Door Alignment – a 0,5mm shim for correction of the door height**DESCRIPTION:**

No. : TB-M2103190

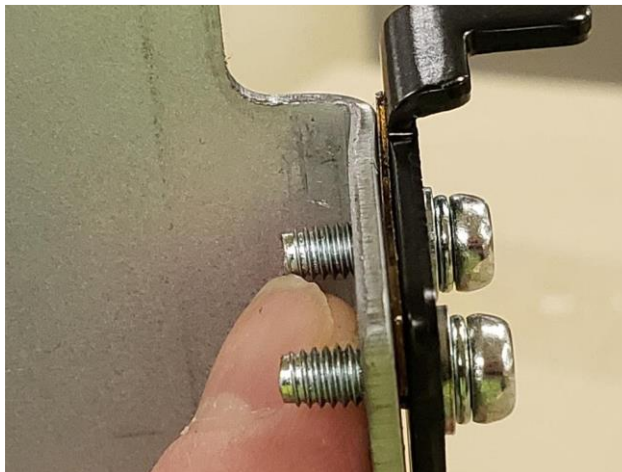
The Door has a tendency to sit lower than the control panel.

In order to raise the Door, a 0.5mm shim (Photo.1) will be fitted between the hinge and the hinge plate.
Loosen the top 2 Hinge screws. (Photo 2)
Insert the Shim into position as shown. (Photo 3 & 4)
Fully Tighten the top 2 Hinge screws. (Photo 5 & 6)
Check Door Alignment.
